CITY OF ALBUQUERQUE

**RE: Coronado Center; The Cheesecake Factory
6600 Menaul Blvd NE Suite 600
Grading and Drainage Plan
Engineers Stamp Date 7/8/15 (H18D005D)**

SHEET TITLE
GRADING & STORM DRAIN PLAN

C1.5

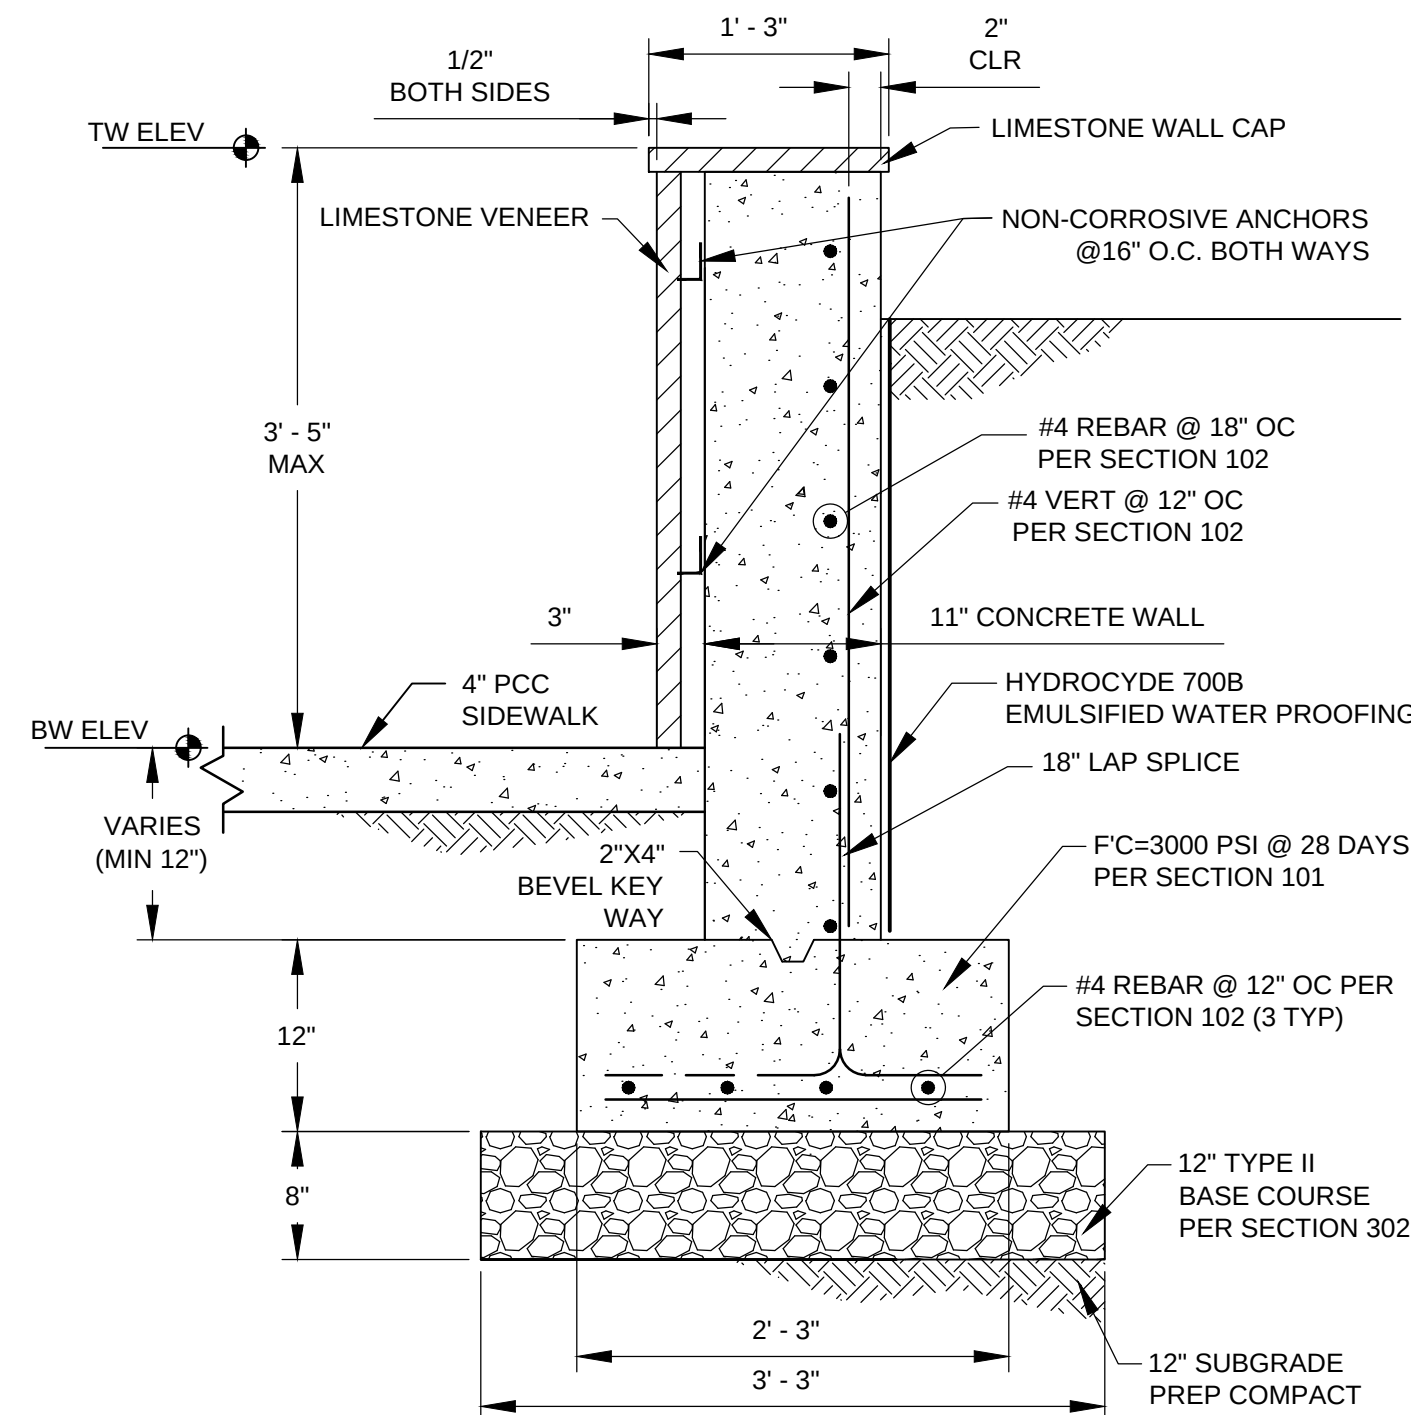
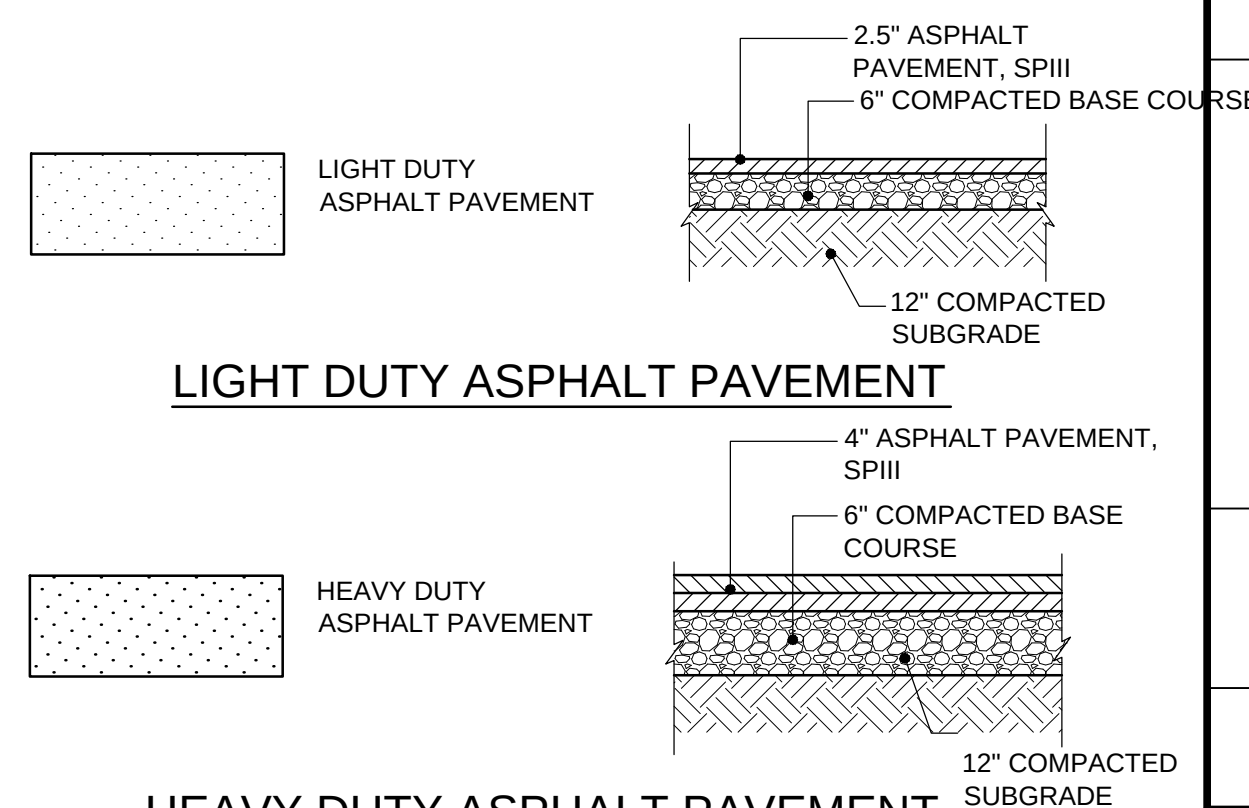
Based upon the information provided in your submittal received 7/9/15, this plan is approved for Grading Permit and Building Permit.

Please attach a copy of this approved plan to the construction sets in the permitting process prior to sign-off by Hydrology.

Prior to Certificate of Occupancy release, Engineer Certification per the DPM checklist will be required.
